PLANNING BOARD AGENDA
JULY 28, 2020 – 7:00 P.M.

RE: Carmel Fire Department
94 Gleneida Avenue
Town of Carmel
TM# 44.14-1-24

With respect to the comments received by the Town Engineering, Richard Franzetti, P.E., dated June 11, 2020 we offer the following:

DRAWING: LAYOUT AND LANDSCAPE PLAN

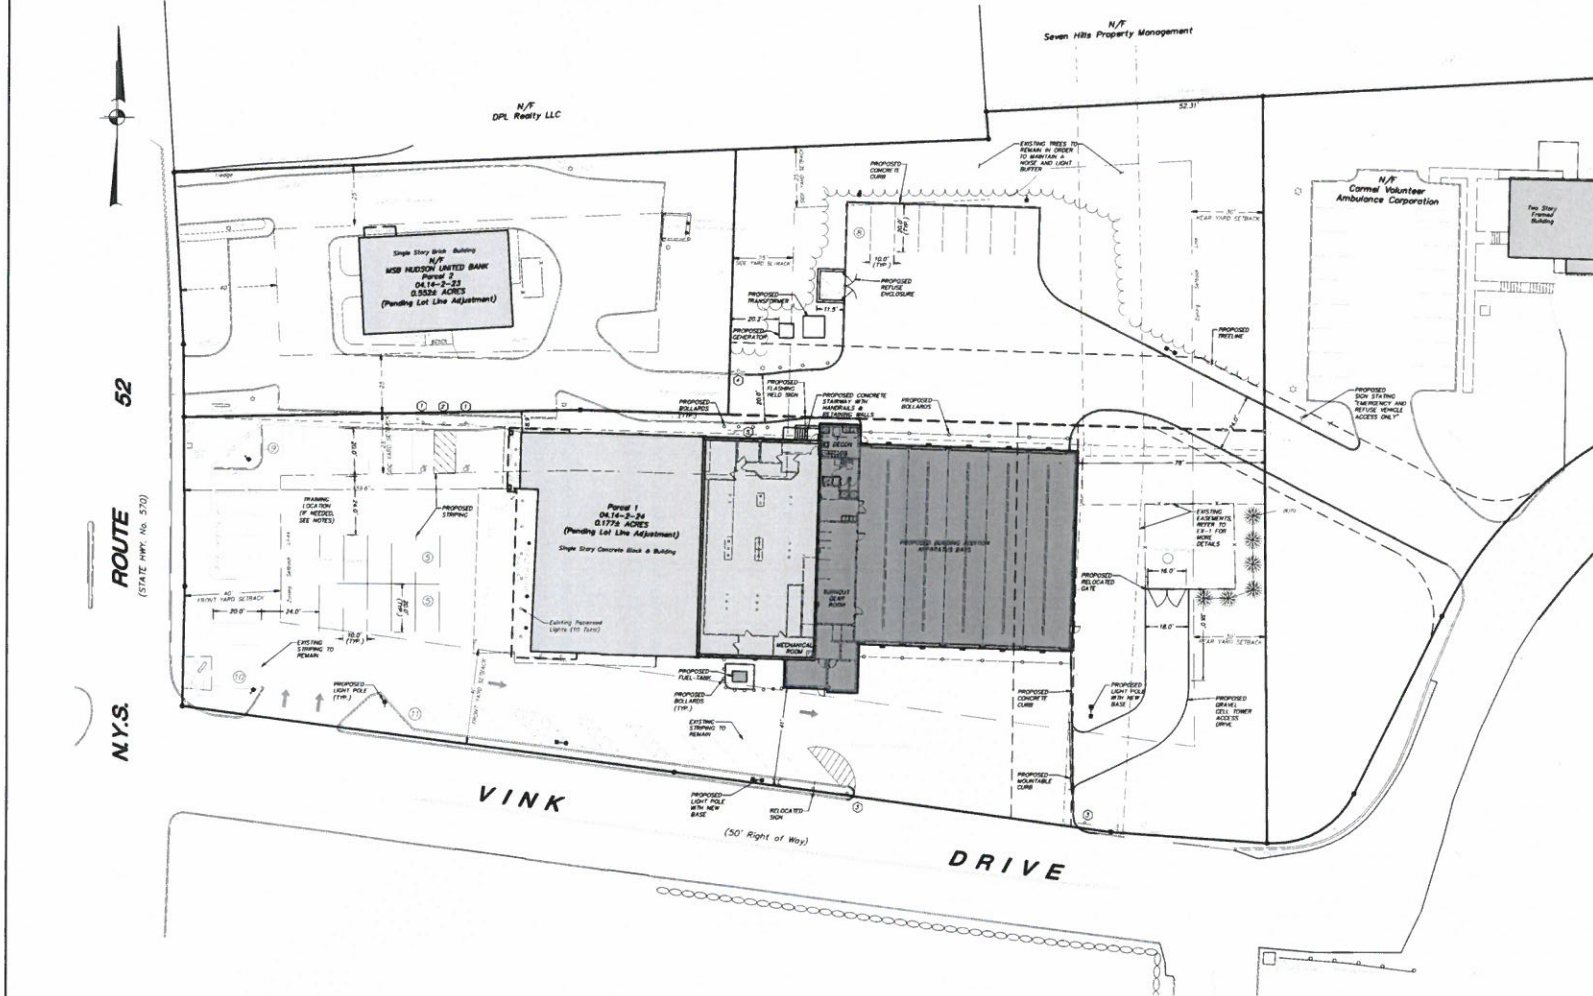
1. Layout and Landscape
 - a. Additional landscape information and notes have been added to SP-1 and landscape details are shown on D-1. The proposed disturbance for the northern asphalt area is concentrated in the portion of the property which contains two grass areas and only several trees. The location was chosen in order to preserve the existing perimeter landscaping to utilize as screening. Additional screening is being provided at the cell tower.

- b. Note has been added to Drawing SP-1.
 - c. Note has been added to Drawing SP-1.
 - d. Noise / Light buffers have been indicated on Drawing SP-1. The two lights near the northern property line include house side shields as shown on Drawing LP-1.

- No comment.
- No comment.
- The driveway accessing the site from TD bank has been clarified as one way. One way signs and a yield to fire apparatus sign is shown on Drawing SP-1. A detail of the yield sign has been added to D-1. The yield sign has a flashing component which will flash when a car approaches the sign.

FIRE TRUCK VEHICLE MANEUVER

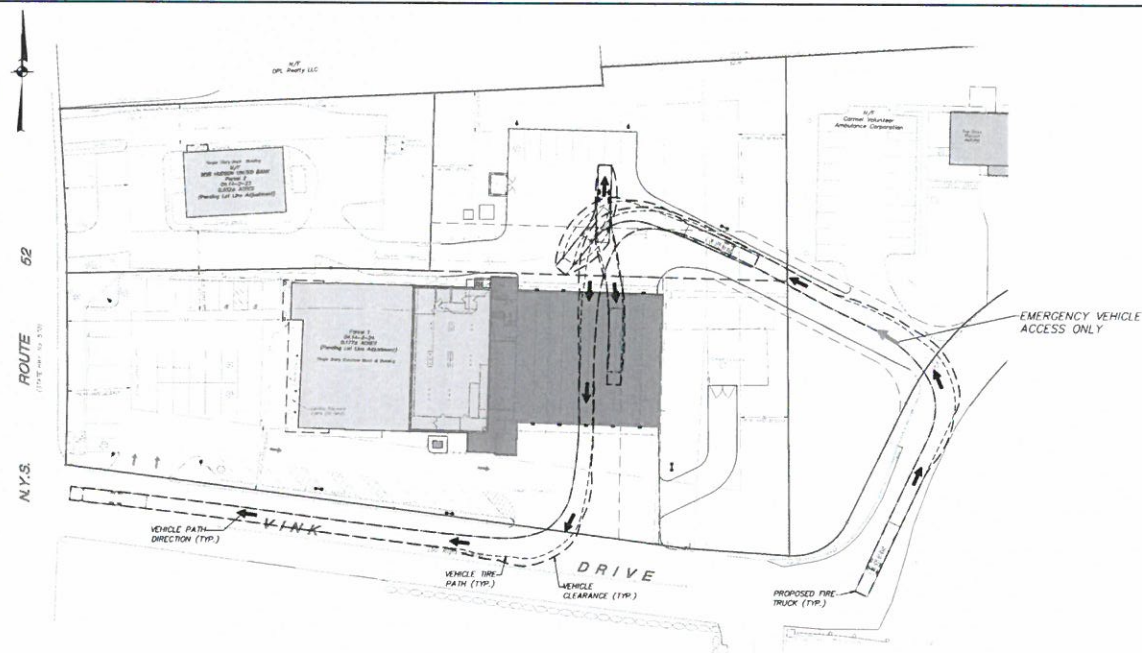
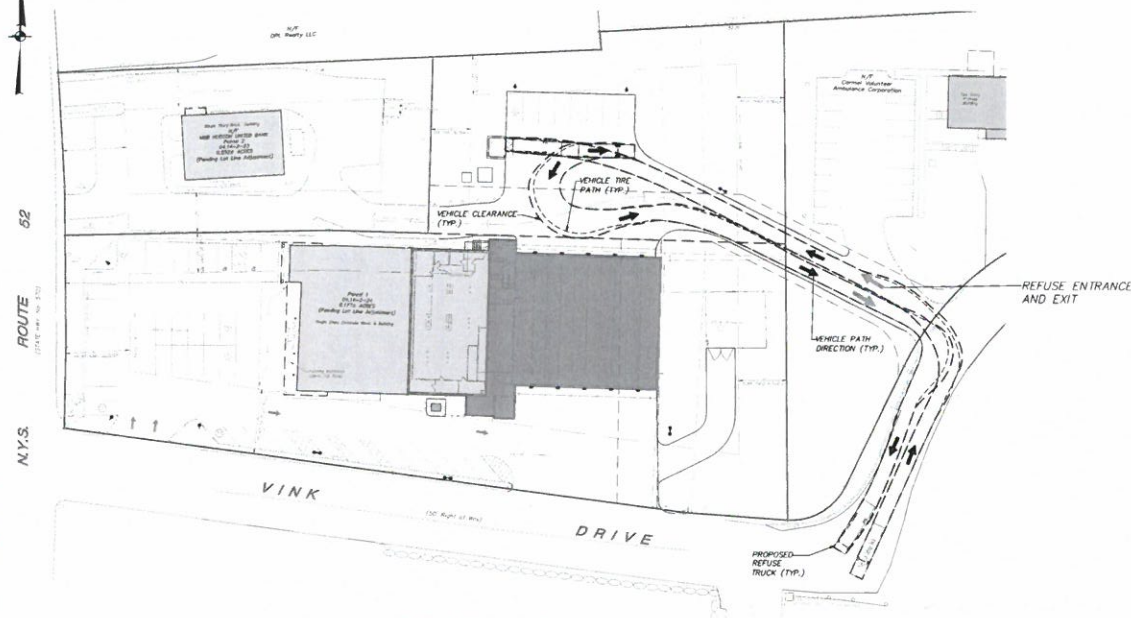
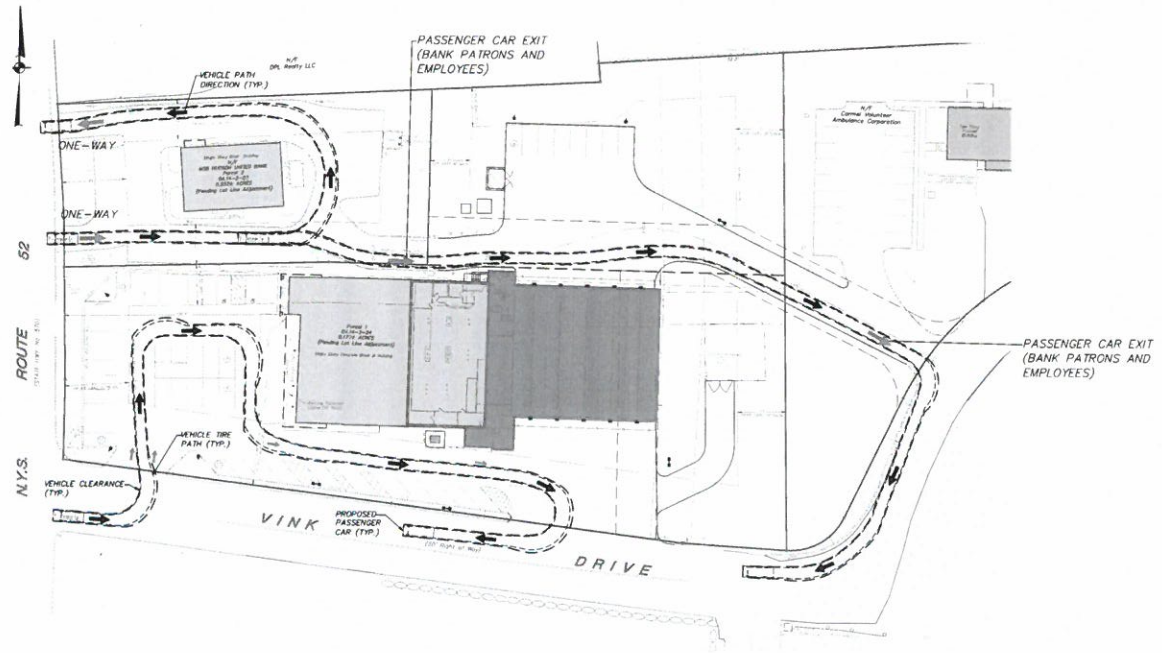
4. All re-grading proposed is shown on SP-2. An additional cut fill calculation has been added to SP-2.
5. Traffic and Vehicle Movement Plans
 - a. Vehicular and Maneuvering Plans have been added to the drawing set as Drawings SP-4 and SP-5. Turning studies include a passenger vehicle, fire apparatus and refuse vehicle.

- No comment.
- The refuse enclosure has been relocated as shown on Drawing SP-1.
- Vehicular maneuvering plans, drawings SP-4 and SP-5, have been added to the drawing set. Additional notes to show the TD Bank circulation is included on SP-5.

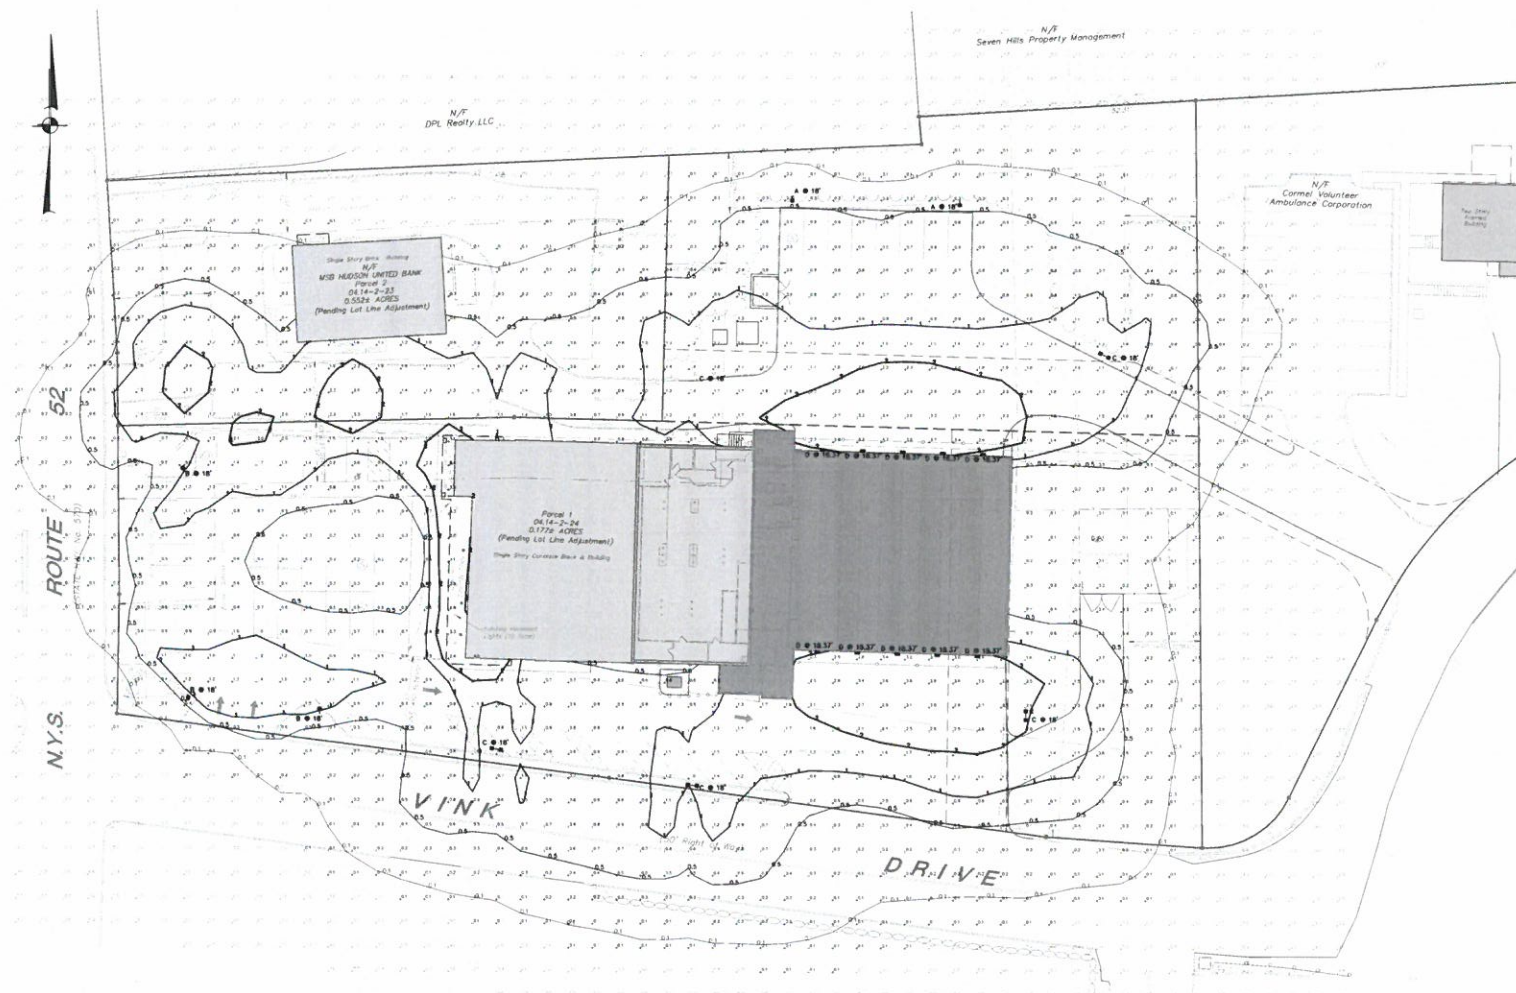
6. A lighting plan has been added to the drawing set as drawing LP-1.
7. Additional hatching and notes have been added to the plans EX-1 and SP-1 in order to clarify the easements.

- There is proposed light fixtures at the garage bay doors of the new addition. New light poles are proposed to replace the existing poles on site. The lighting plan, Drawing LP-1, has been added to the set for additional information.
- The existing and the proposed generators are for emergency power only. The proposed unit is a 180kw unit. Noise level has been added to Drawing SP-3.
- The existing fuel system is being replaced with the proposed 500 gallon fuel tank, pump and dispenser. A detail of the fuel system is shown on Drawing D-2. The tank is an above ground tank with less than 1,000 gallons storage so a Petroleum Bulk Storage Registration is not required by the New York State Department of Environmental Conservation.
- No alarms or bells are proposed on the building. There is an existing alarm horn on site but it is not hooked up and will be removed as part of this project.

PROJECT TITLE
EXTERIOR ELEVATIONS
AND DETAILS

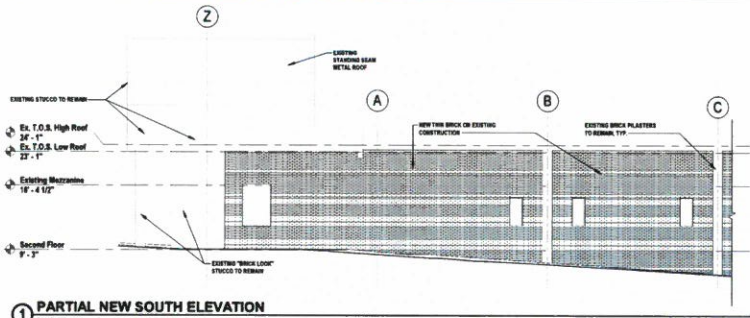
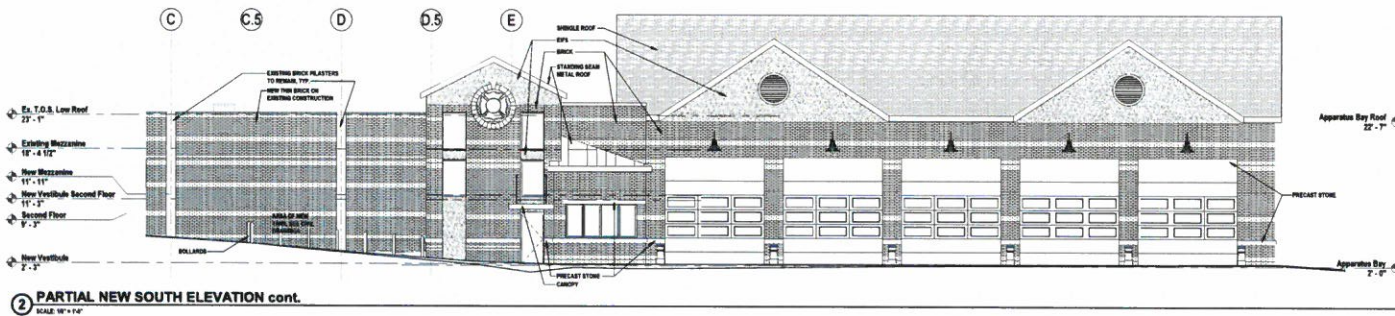
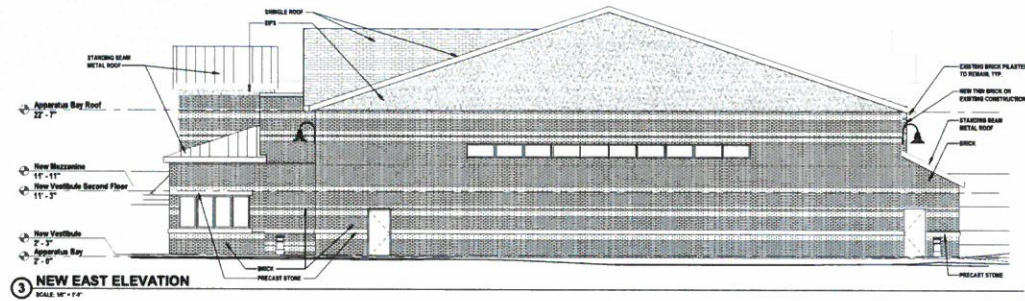
- No comment.
- No comment.
- Architectural elevations are included in the attached submission.
- The Building will not interfere with the cell tower. The applicant is in communication with the cell tower group to coordinate both the proposed site plan and utility configuration.
